UNITED STATES PATENT AND TRADEMARK OFFICE

Office Action Summary

10/719,215

DETAILED ACTION

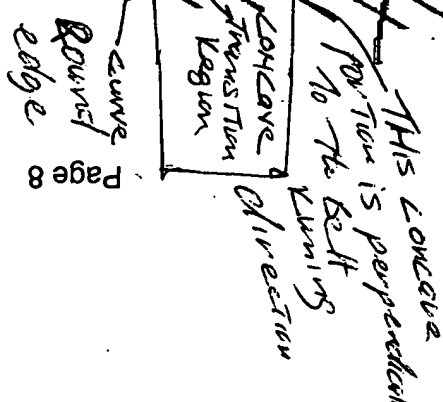
2. Claims 1-2, 9 and 11, as understood, are rejected under 35 U.S.C. 102(b) as being anticipated by JP (63-266248) to Anpo et al. Anpo et al. discloses transverse element comprising a supporting surface (see attached drawing), a pulley sheave contact surface (38), a transition region (see attached drawing in) which is connected to the supporting surface at one section and to the pulley sheave at another section, wherein the transition region inherently comprises a concave portion. Anpo et al. also disclose the concave region is in a plane perpendicular to the belt circumferential direction (see attached drawing)

In claim 2, note the transition edge region comprises a distance surface (see attached drawing) connecting to the pulley contact surface via the inherently concave portion.
